SAFETY EVALUATION BY THE OFFICE OF NEW REACTORS
RELATED TO AMENDMENT NO. 1 TO THE COMBINED LICENSE NO. NPF-91
AND LICENSE NO. NPF-92
SOUTHERN NUCLEAR OPERATING COMPANY, INC.
GEORGIA POWER COMPANY
OGLETHORPE POWER COMPANY
MUNICIPAL ELECTRIC AUTHORITY OF GEORGIA
CITY OF DALTON, GEORGIA
VOGTLE ELECTRIC GENERATING PLANT UNITS 3 AND 4
DOCKET NOS. 52-025 AND 52-026

Figure 1. Proposed Revision to UFSAR Figure 3H.5-3

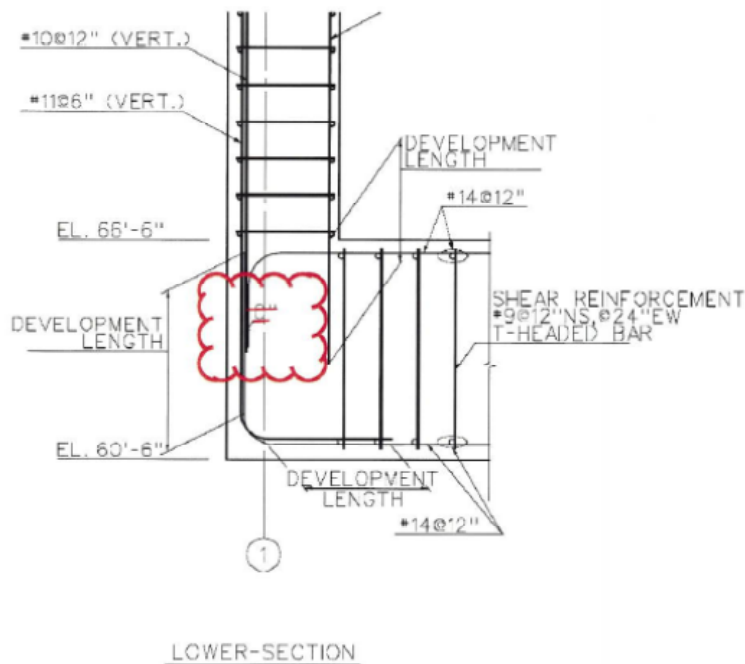
Under the LAR, the licensee also proposed to revise UFSAR Figure 3H.5-3, which is Tier 2* information, by removing the dimension, labelled as 0-inches, in the portion of the figure showing the junction of the basemat and exterior nuclear island wall (along Column Line 1). The 0-inch dimension indicates that vertical reinforcement at this location will be in the same vertical plane (Figure 1 below). The LAR states that removing the dimension does not change the design of the basemat or conformance with the ACI 349-01 code.

In LAR Section 3, the licensee proposed to revise UFSAR Figure 3H.5-3 to remove the dimension labeled 0-inches in the portion of the figure showing the basemat below the wall. This section also states that the particular dimension is being removed for the Vogtle design, as the hook-end and vertical wall reinforcement will not be aligned in the same vertical plane. The licensee concluded that the design revision does not change the design of the basemat longitudinal or shear reinforcement.

The staff performed a review of the proposed change to UFSAR Figure 3H.5-3, and it concludes that the removal of the dimension labeled as 0-inches does not reduce the capacity of the basemat to exterior wall joint or conflict with ACI 349 code provisions. Accordingly, the staff concludes that the design revision has no impact on the design of the basemat.

6. The removal of the dimension labeled as 0-inches in Tier 2* Figure 3H.5-3 does not affect the ability of the critical section joint to perform its function under design-basis demands or conflict with ACI 349-01 code provisions. Accordingly, the staff concludes the design revision has no impact on the design of the basemat.
